Access Compliance Report Public Rights-of-Way (Curb Ramps)

Main Street: NEWPORT_AVE Cross Street: CHARWOOD_LN Location: N

ADA ID: RPRK211008131442 Ramp Type: Type 1 - Perpendicular Diagonal Initial Pass/Fail: Fail Overall Compliance: No Severity Score: 15

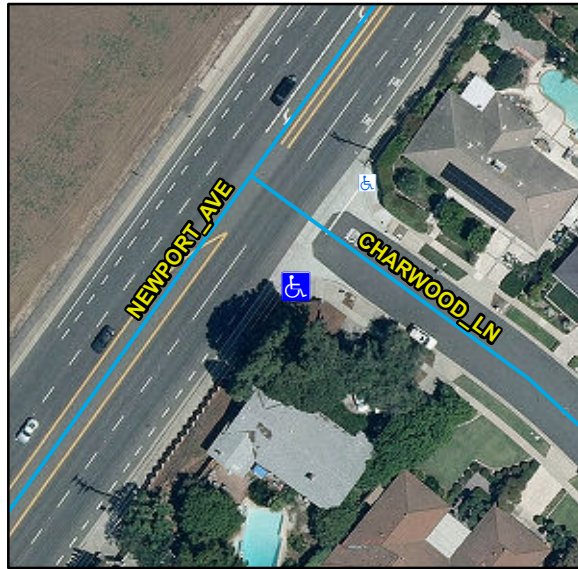
Compliance	Description	Data	Compliance	Description	Data
N/A	Ramp Length (in)	125	N/A	Flare Type LT	
Yes	Ramp Width (in)	48			N/A
No	Ramp Run Slope (%)	10.2	N/A	Flare Slope LT (%)	N/A
Yes	Ramp Cross Slope (%)	1.2	N/A	Flare Traversable LT	N/A
N/A	Landing Present	N/A	N/A	Flare Type RT	
N/A	Landing Length (in)	N/A			N/A
N/A	Landing Width (in)	N/A	N/A	Flare Slope RT (%)	N/A
N/A	Landing Run Slope (%)	N/A	N/A	Flare Traversable RT	N/A
N/A	Landing Cross Slope (%)	N/A	N/A	DWS Provided	N/A
N/A	Landing Movement Obstructed?	N/A	N/A	DWS Contrast	N/A
	Landing Movement Type	N/A	N/A	DWS Length (in)	N/A
N/A	Landing Shared	N/A	N/A	DWS Full Width	N/A
N/A	Clear Space	Yes	N/A	DWS Offset Left (in)	N/A
N/A	Clear Space To Crosswalk (in)	N/A	N/A	DWS Offset Right (in)	N/A
N/A	Marked Crosswalk 1	No	N/A	Marked Crosswalk 2	No
	Crossing 1 Direction	E		Crossing 2 Direction	S
	Marked Crosswalk 1 Width (in)	N/A		Marked Crosswalk 2 Width (in)	N/A

N/A	Ramp Inside Crosswalk 1	N/A	Yes	Ramp Inside Crosswalk 2	N/A
	Crossing 1 Slope (%)	5		Crossing 2 Slope (%)	4.6
	Crossing 1 Cross Slope (%)	2.6		Crossing 2 Cross Slope (%)	2.1
N/A	Gutter Ponding	N/A	No	Curb Slope	16.2
Yes	Gutter Lip Height (in)	0		Road Run Slope (%)	4
N/A	Gutter Run Slope (%)	N/A		Road Cross Slope (%)	5.2
N/A	Gutter Cross Slope (%)	N/A			
Yes	Overall Surface Condition: Acceptable		Yes	Perp Joint Present	Yes
	Cross Gutter Present?	No		Spandrel Present?	No
	Replace Cross Gutter?	N/A		Replace Spandrel?	N/A

Remove & Replace Curb Ramp With Two New Directional Ramps or Equivalent.
